MIL-C-39029/102A
AMENDMENT 1
21 June 1999

MILITARY SPECIFICATION SHEET

CONTACTS, ELECTRICAL, CONNECTOR, PIN, CRIMP REMOVABLE,
COAXIAL, SIZE 12, (FOR MIL-C-38999 SERIES I, II, III AND IV CONNECTORS)

This amendment forms a part of MIL-C-339029/102, dated 31 March 1988, and is approved for use by all Departments and Agencies of the Department of Defense.

Figure 1:

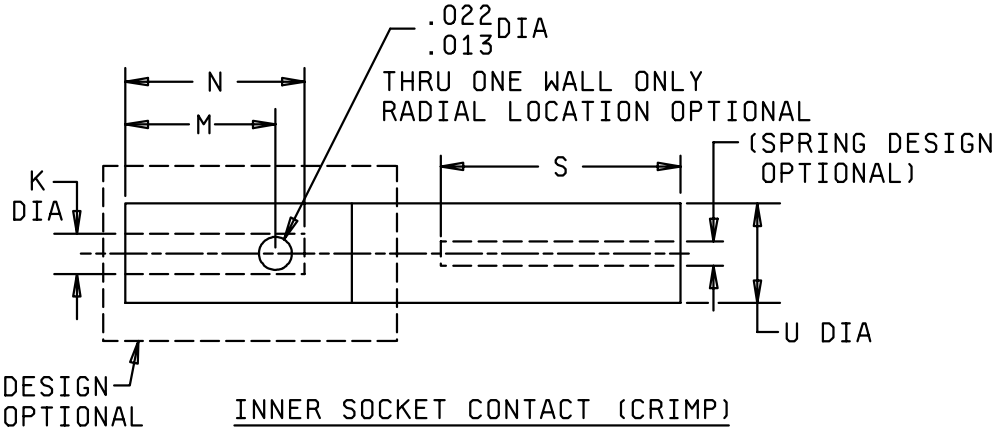
Figure 1, replace the “INNER SCOKET CONTACT (CRIMP)” detail drawing, with the following:
“

Delete the “L ref” dimension from the table.

Change the “U” dimension in the table as follows: “ From: .034/.031 To: .0350/.0310 “

Replace the N dimension with “ N: .084 min, .100 max ”.
Replace the M dimension with “ M: .063 min, .088 max ”.

Figure 2. Vibration envelope.

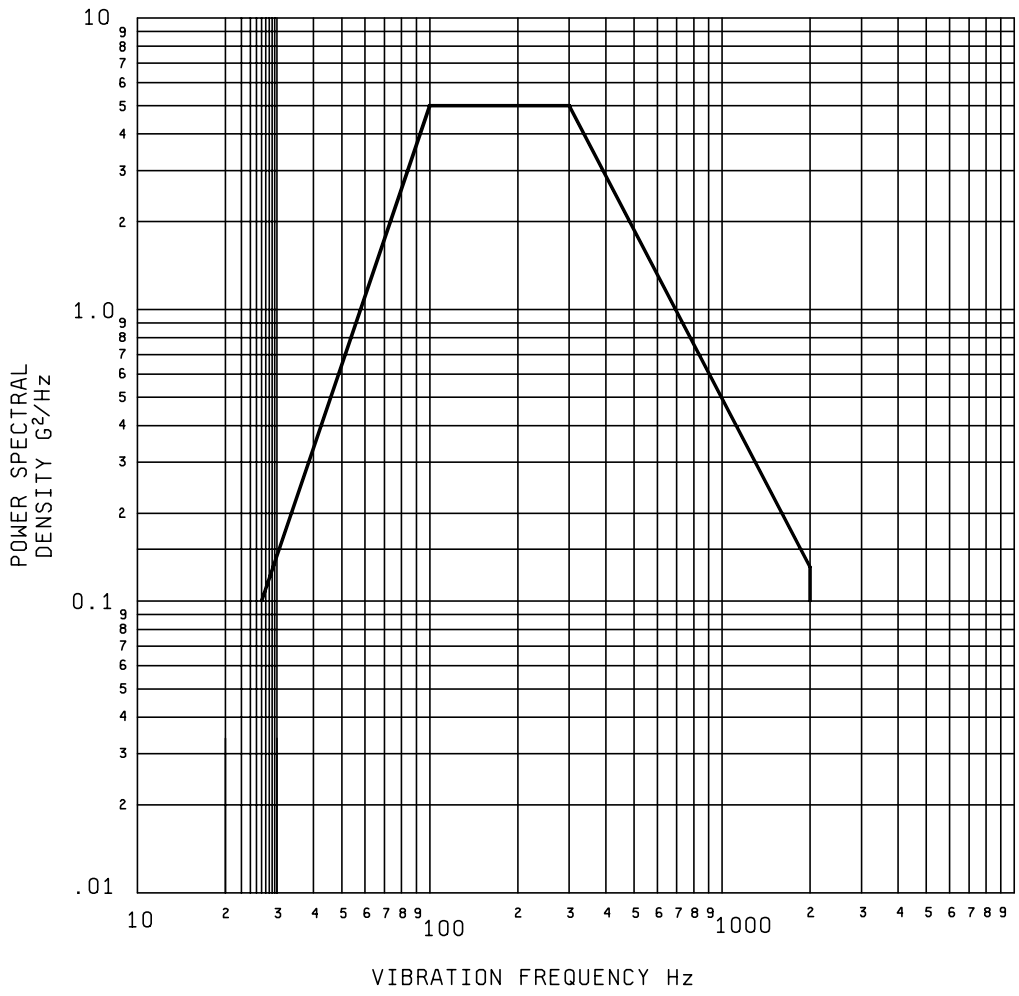
Change Random Vibration as follows:

Delete subparagraph a, and substitute the following:
" a. Test condition V. Use the vibration envelope shown on figure 2 herein".
